SERVICE INFORMATION

STANDARD AND TRIUMPH VEHICLES

No.	SPORTS/3/J	REINFORCED JACKING SYSTEM	Date	MARCH 1955
------------	------------	---------------------------	-------------	------------

1 ILLUSTRATION.

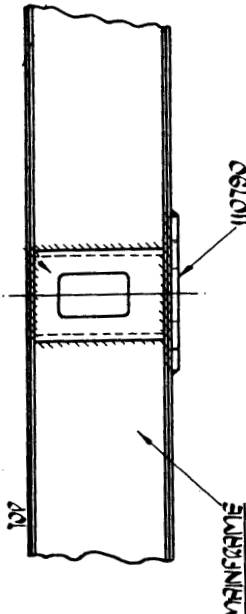
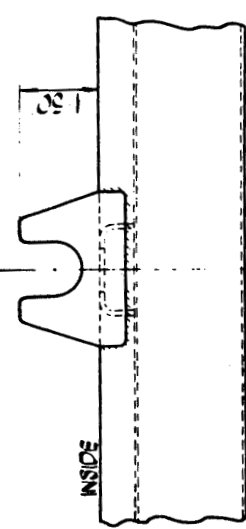
In order to enable the strengthened jack to be used on cars prior to Commission No. TS.5469, a slight modification to the position of the jacking bracket is necessary.

Where it is necessary to modify the jacking position, the old bracket must be carefully removed from the frame and the new Bracket and Guide, Part Nos. 110791 and 110790 respectively, welded to the frame.

When carrying out this modification the bracket must be lined up with the hole in the car floor and then welded in position. Following the bracket the guide plate should be welded in position to the dimensions given in the illustration.
